# SITE IMPROVEMENTS

### 67 ENTERPRISE DRIVE

BML TOOL, INC.  
67 ENTERPRISE DRIVE  
MONROE, CONNECTICUT

This document has been prepared in response to the comments below received from the Monroe Engineering Department on 02/24/2022. Responses from JEA are in blue

S-1

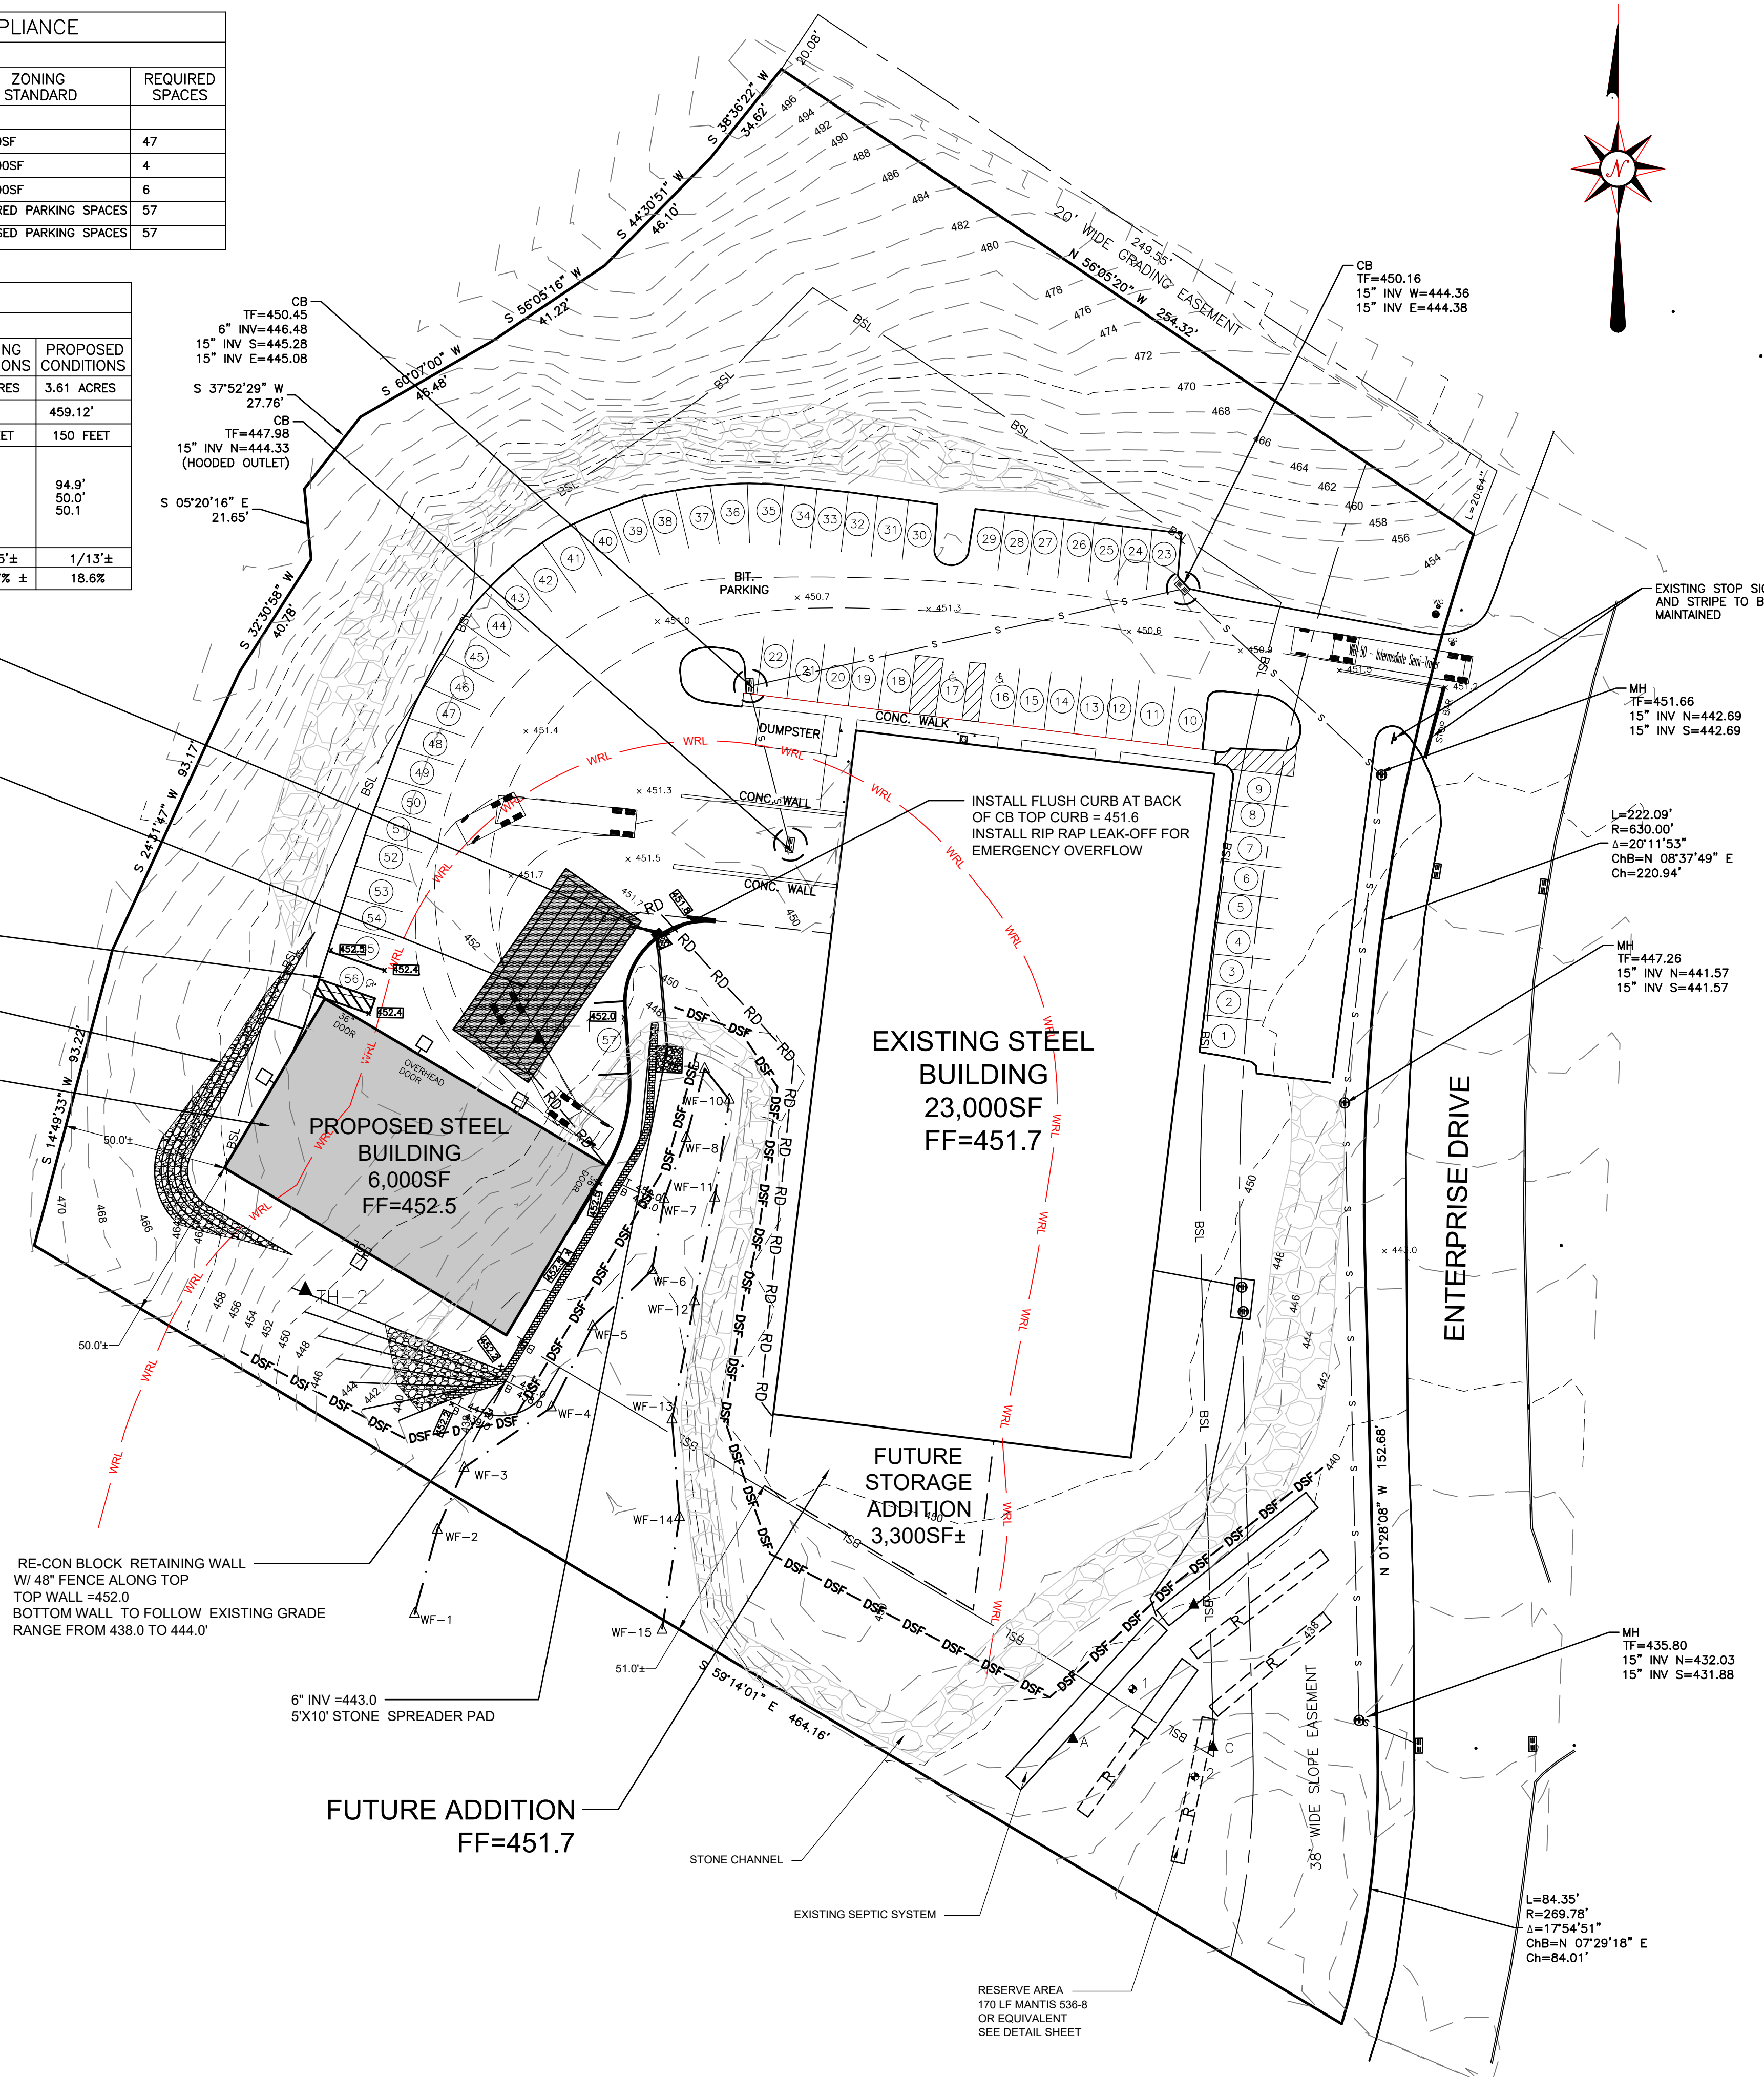
- ~~1. The stop sign at the site exit should be indicated on the plans, and existing line striping should be re-painted/maintained when possible.~~
2. Handicap parking and respective access to the proposed building should be shown (include dimensions and elevations. **Contrary to the 2-28-22 response, the Building Department has confirmed that handicap parking is required, and therefore should be indicated.**

3. The location of access points (doors) to the proposed buildings should be indicated. **Contrary to the 2-28- 22 response, the Building Department has confirmed that a separate hinged door is required, and therefore should be indicated (see note below).**

A Handicap space has been added in front of the new building.

A hinged door location has been added to front of the building

4. ~~In reviewing the plan in comparison to the stormwater management plan (calculations), it appears that the pipe size/data on the plans is the opposite of the intended layout. Accordingly, the plans should be revised to reflect a 5" outlet leaving the detention system, and a 12" outlet leaving the catch basin/manhole.~~ Also a detail of the restriction of the 6" pipe to 5" size should be provided. **The plans indicate "6" control outlet restricted to 5" Inv 447.5, but the Stormwater Management Plan indicates a 5" orifice with invert elevation 446.5**

Revised
